9/13/96	Class B Concrete changed to Class A.
6/14/96	Notes added to clarify plans.
DATE	REVISION
STATE OF HAWAII DEPARTMENT OF TRANSPORTATION HIGHWAYS DIVISION	
DRAINAGE PLAN	
KALANIANA'OLE HIGHWAY RESURFACING	
Kailua Rd. to Hilo St.	
Project No. 72A-01-96M	
Scale: 1"=40'	Date: May 1996
SHEET No. 44 OF 44 SHEETS

KALANIANA'OLE HIGHWAY RESURFACING

Project No. 72A-01-96M

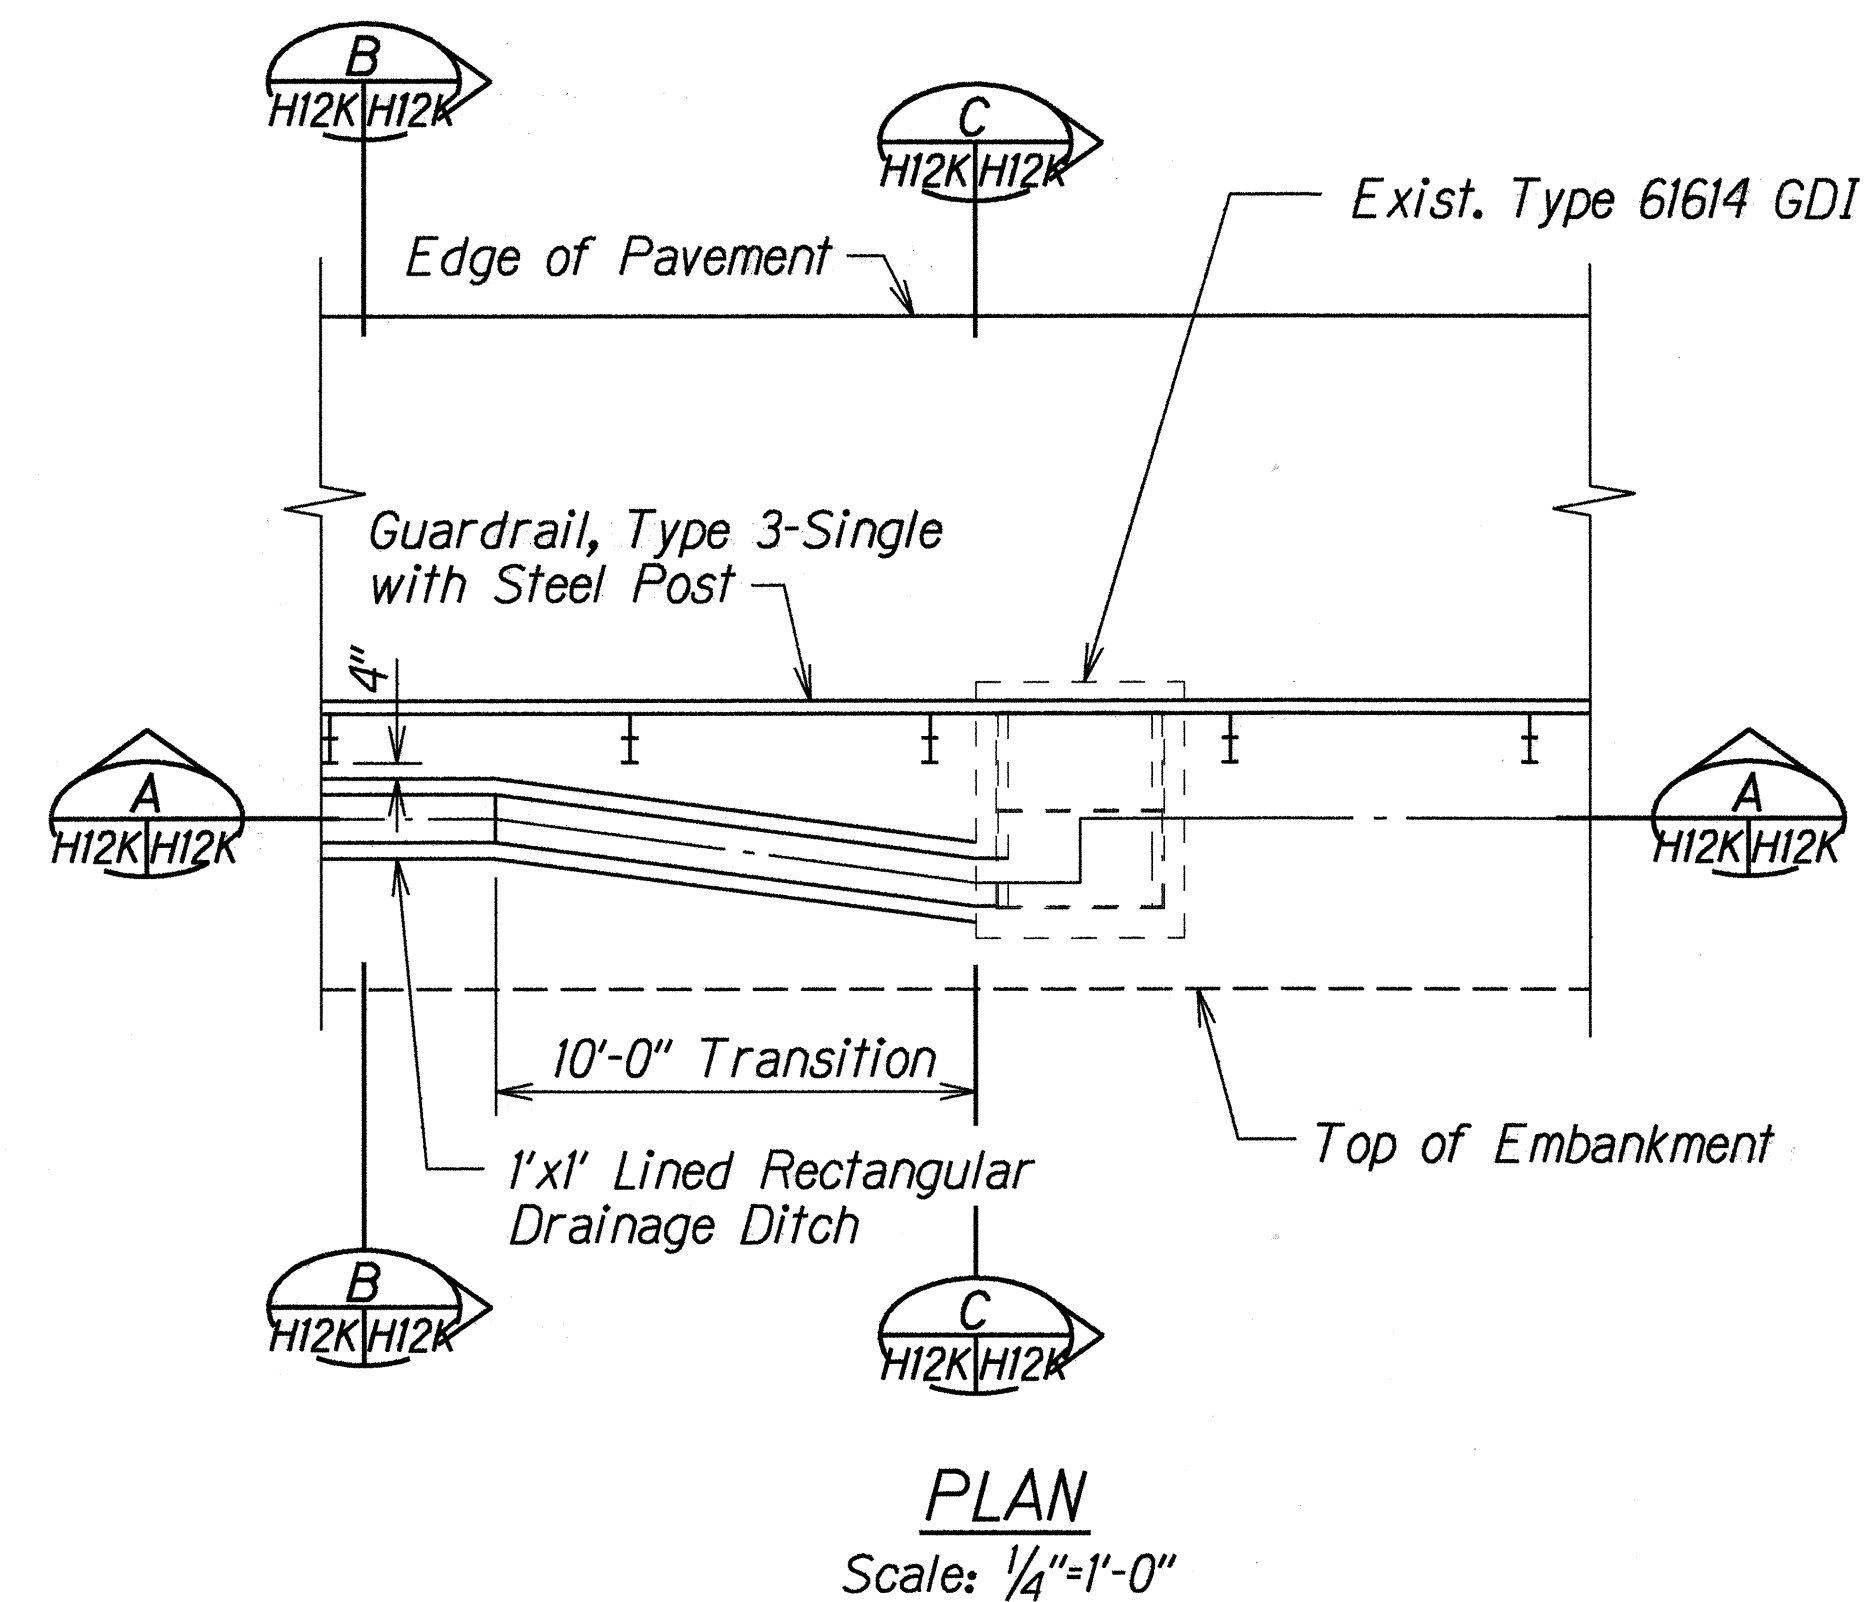
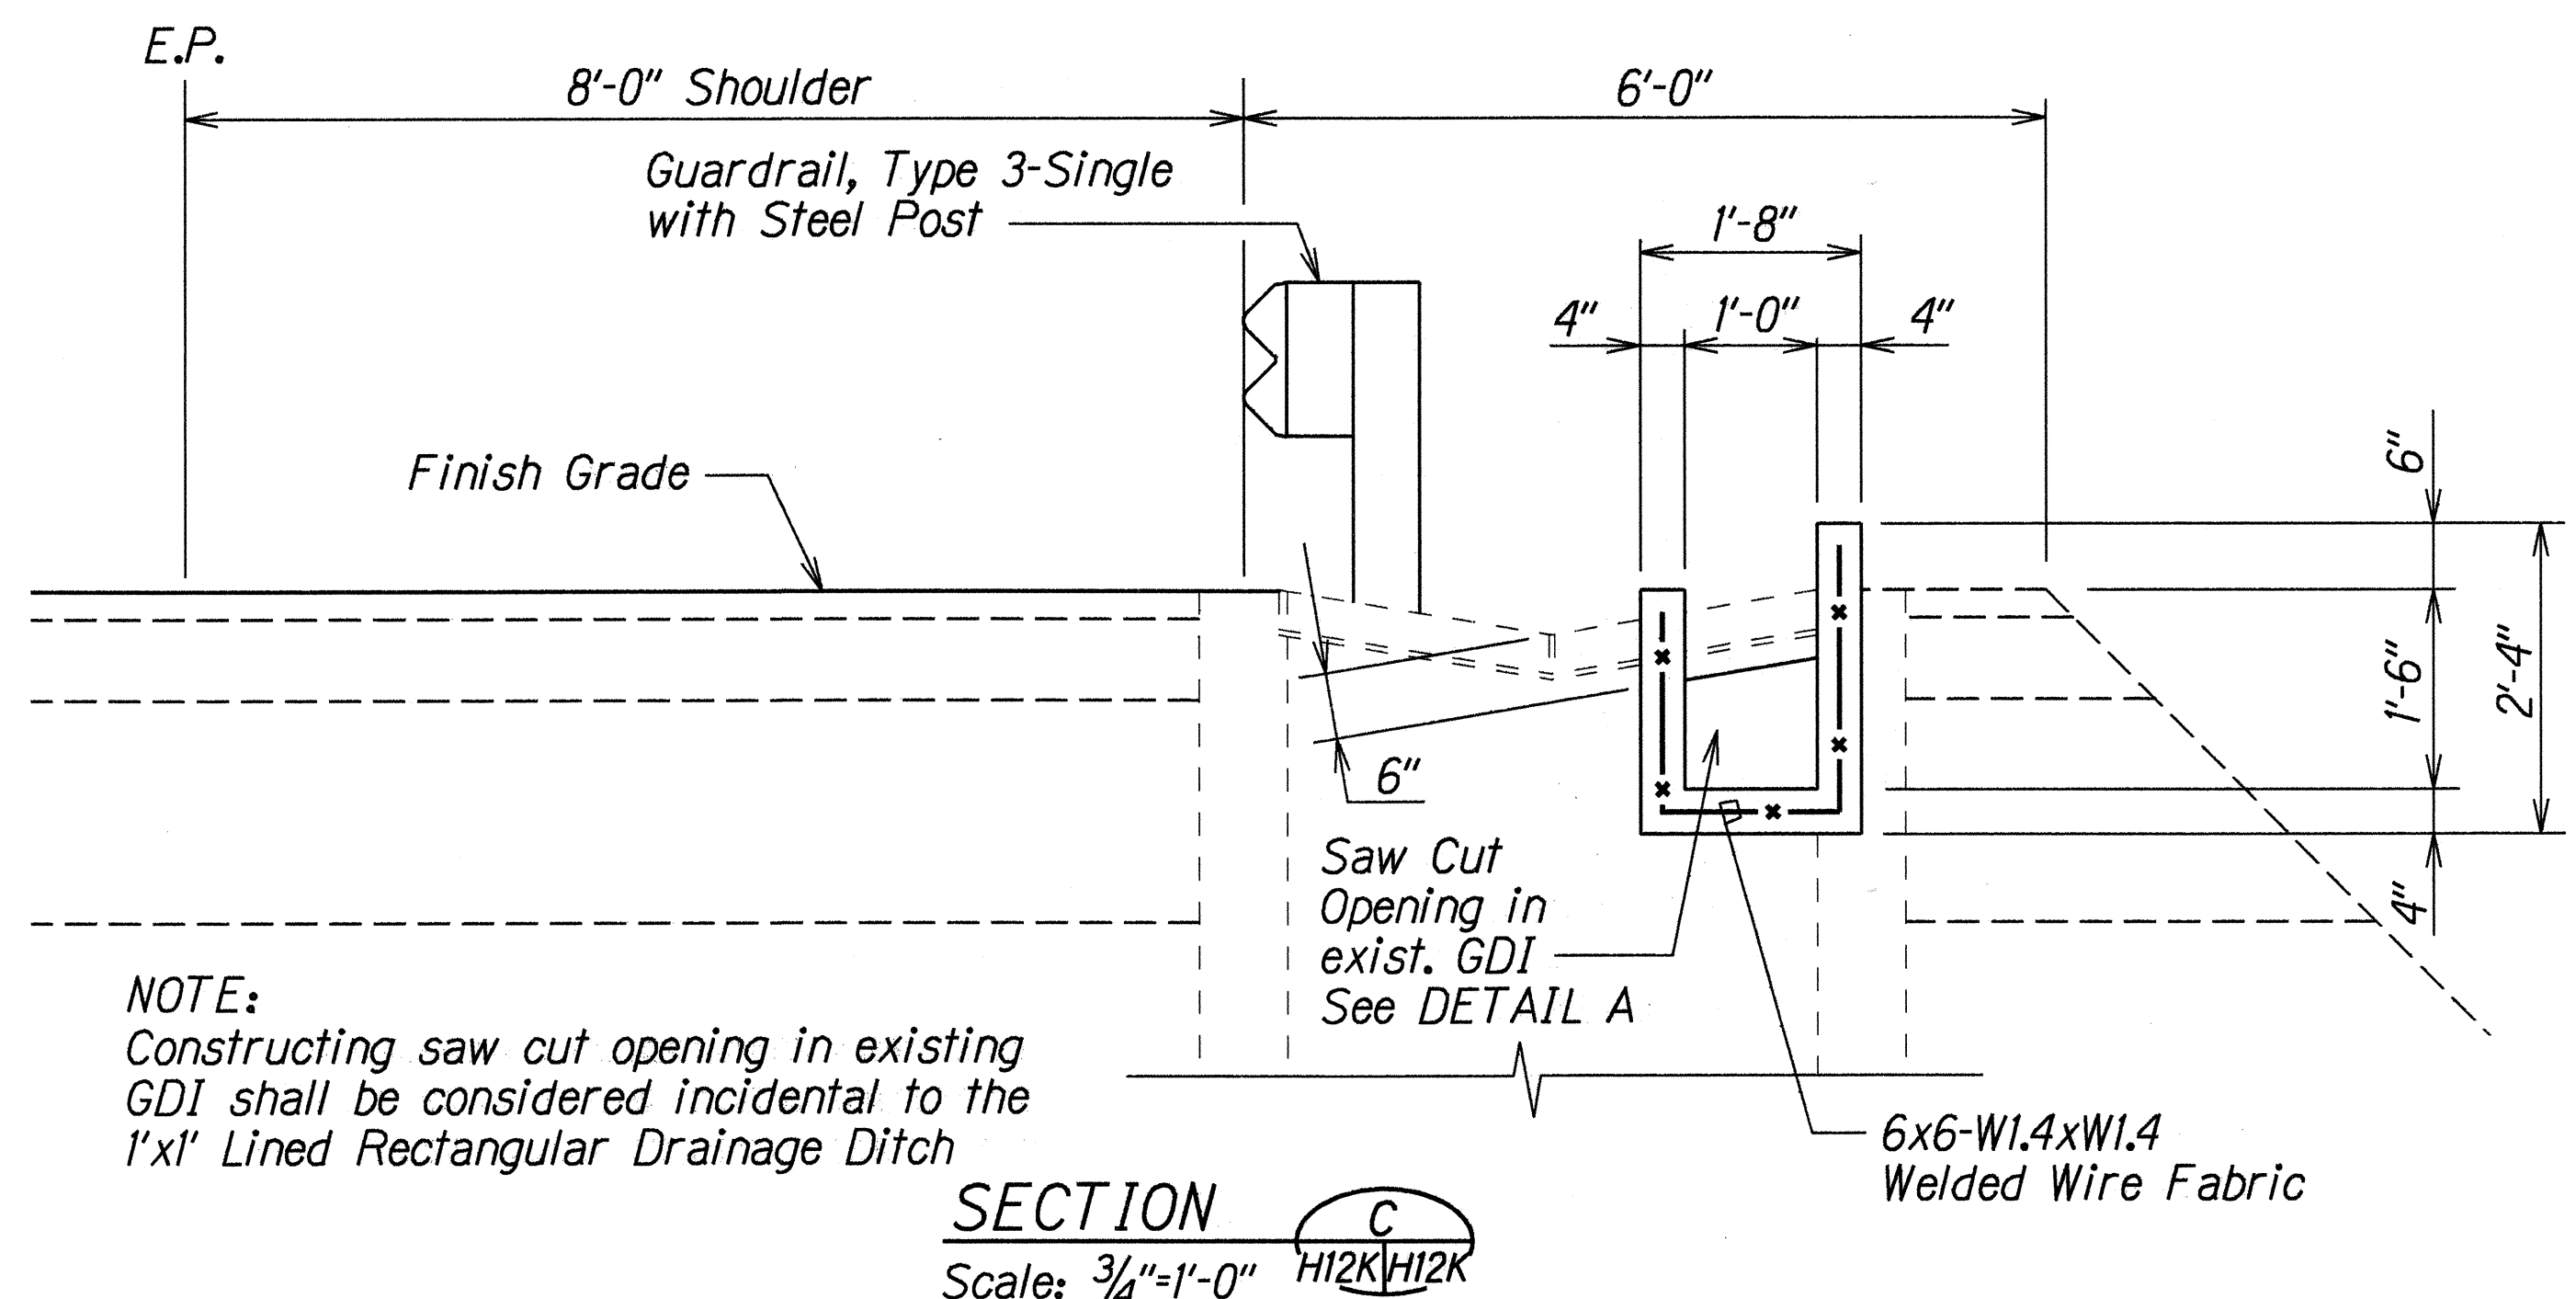
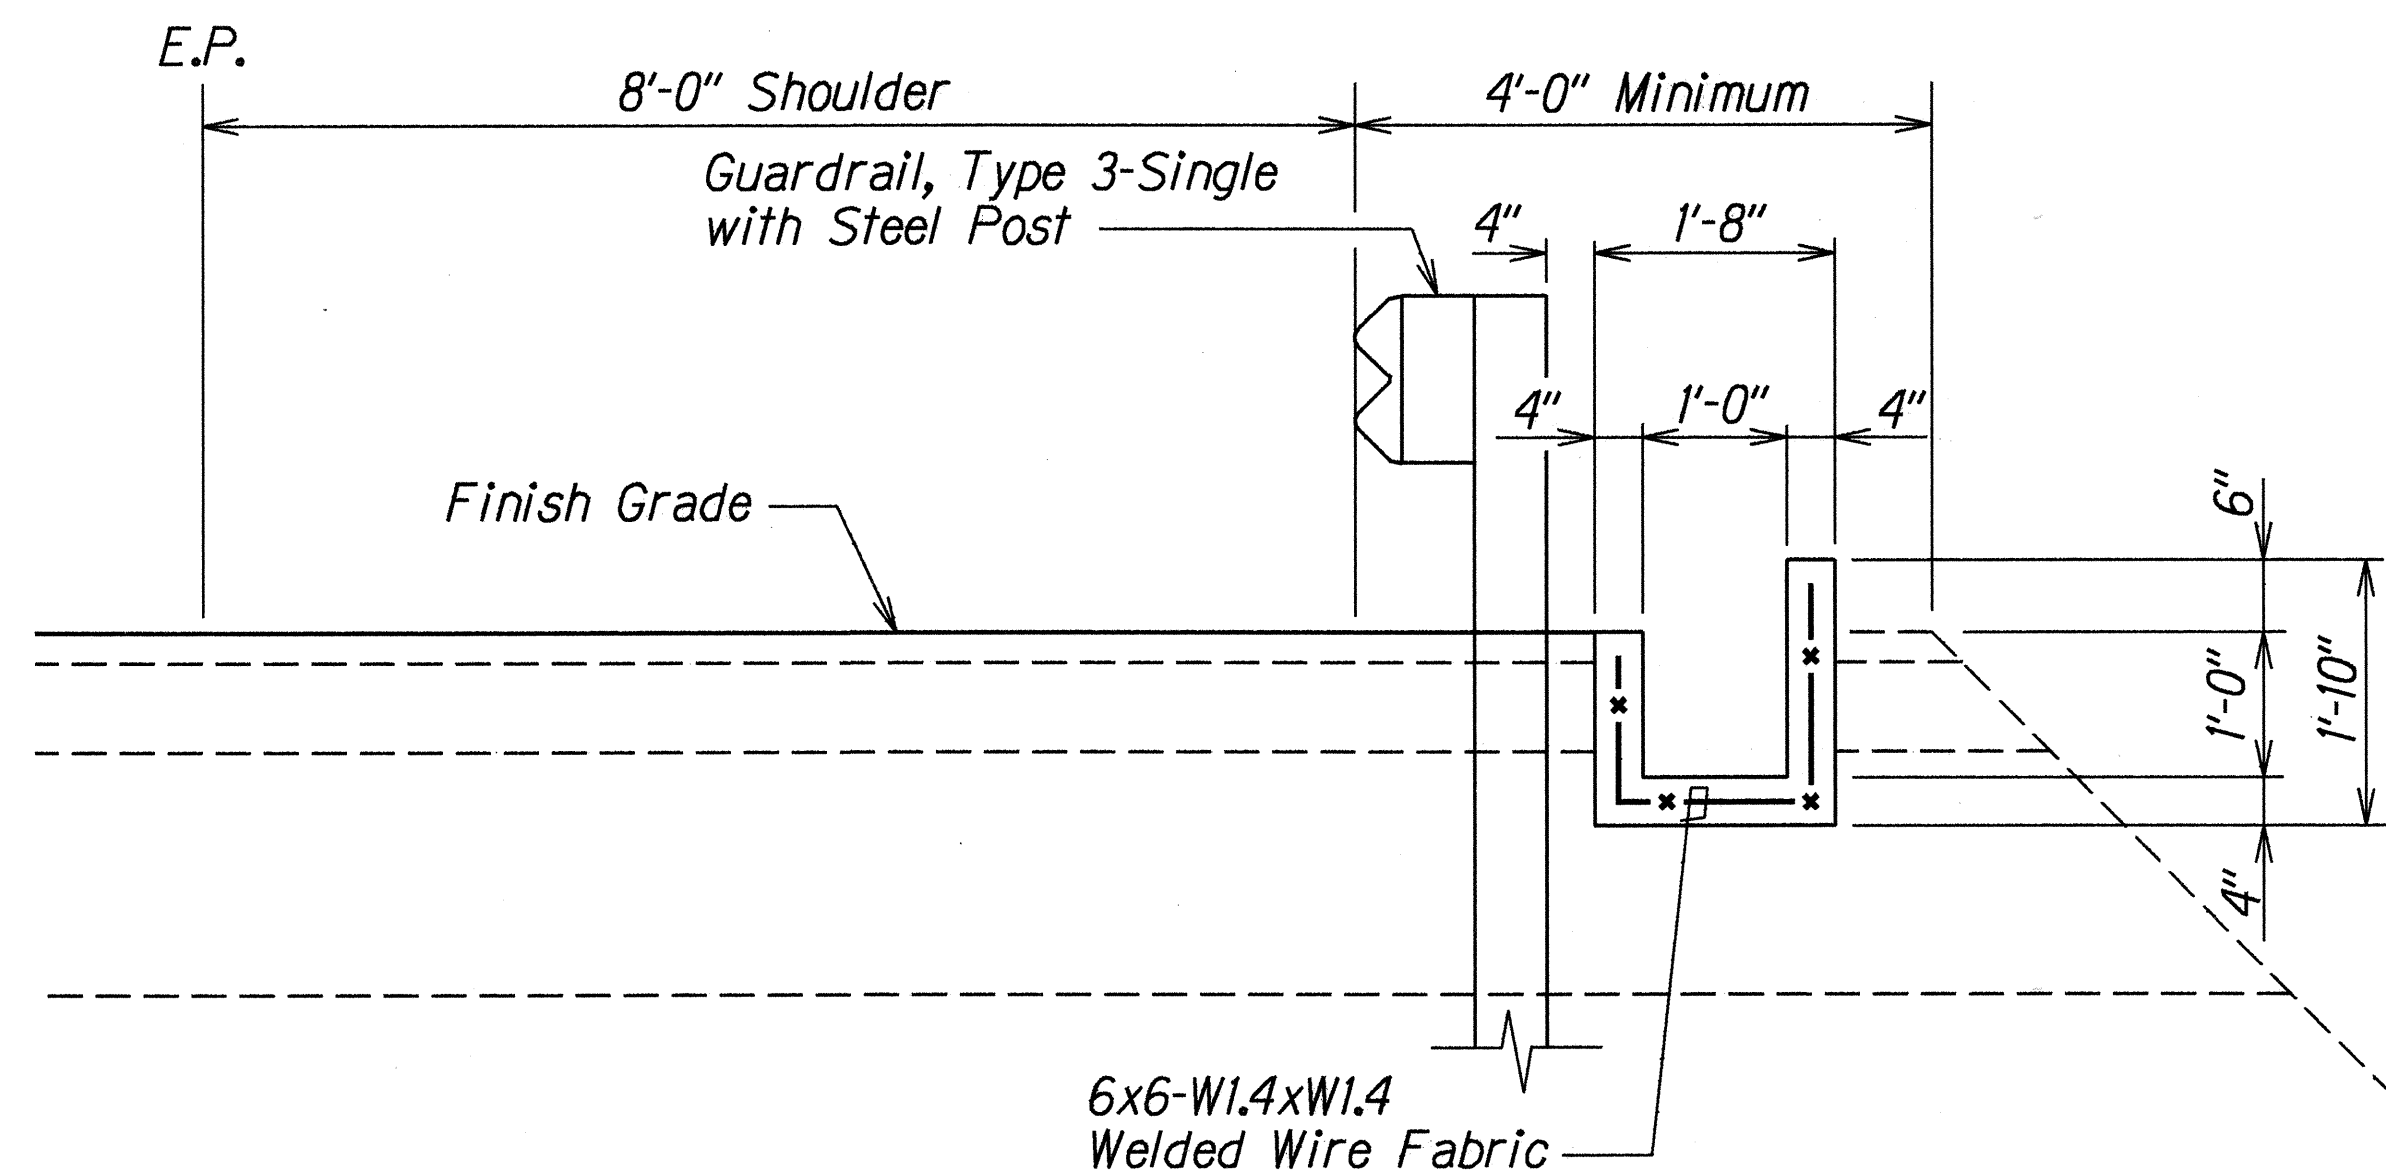
12/5/96	Delete Portion of 1'x1' Lined Rectangular Drainage Ditch.
9/13/96	Sheet added to show details of 1'x1' Lined Rectangular Drainage Ditch.
DATE	REVISION
STATE OF HAWAII DEPARTMENT OF TRANSPORTATION HIGHWAYS DIVISION DRAINAGE DETAILS KALANIANA'OLE HIGHWAY RESURFACING Kailua Rd. to Hilu St. Project No. 72A-01-96M Scale: As Shown Date: Jul. 1996 SHEET No. H12K OF 12 SHEETS
